1904 BELLAMAH AVE NW
ALBUQUERQUE, NM

TRAFFIC CIRCULATION LAYOUT

SP-1

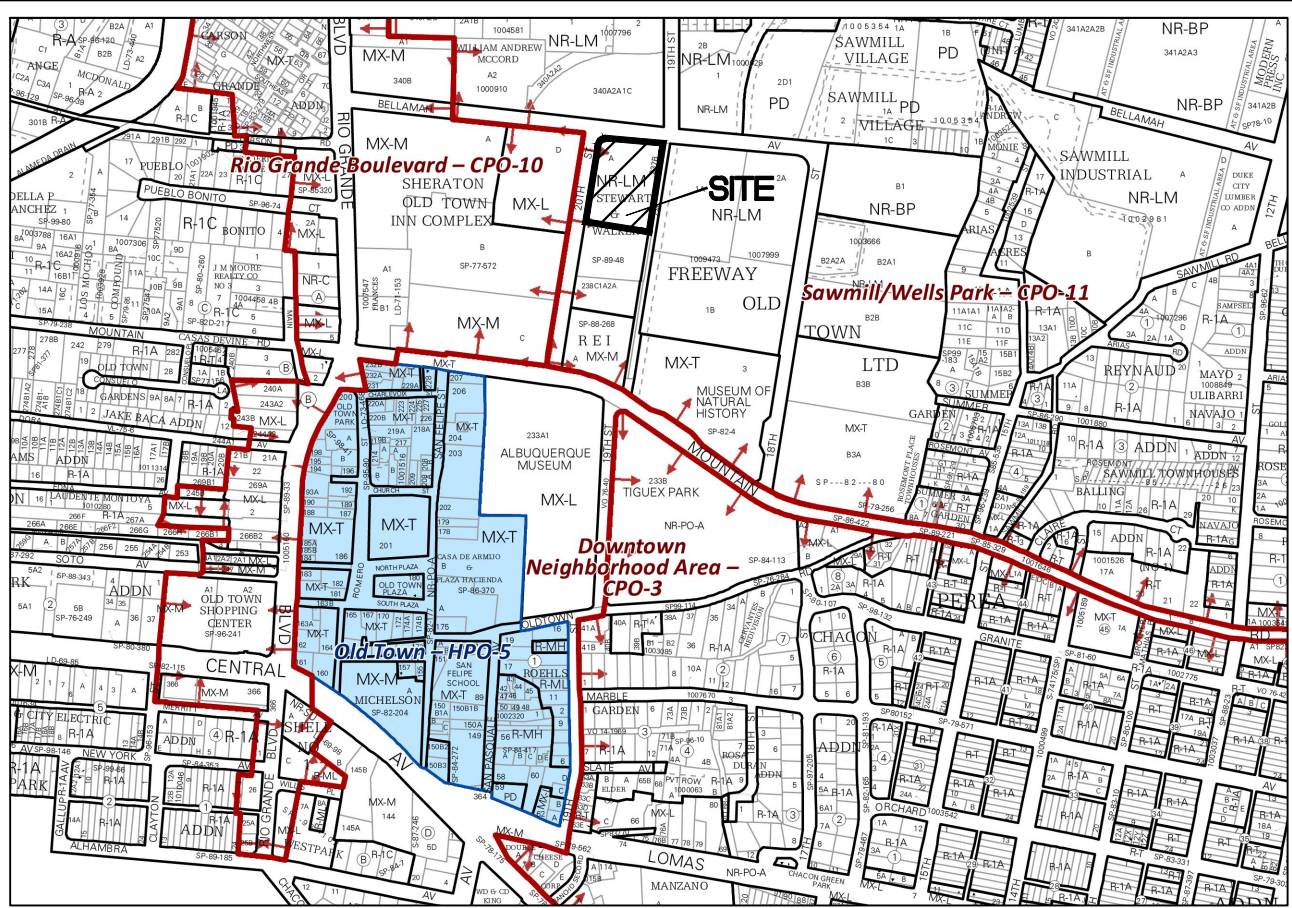
Approved for access by the Solid Waste Department
for up to 12-2 cubic yard Swanson containers(2 Swanson's to be kept in the trash room)
An Access code/card will be given to the refuse driver. Access to the Swanson containers
from 5AM to 8PM will be required. Herman Gallegos 04-21-23/Herman Gallegos
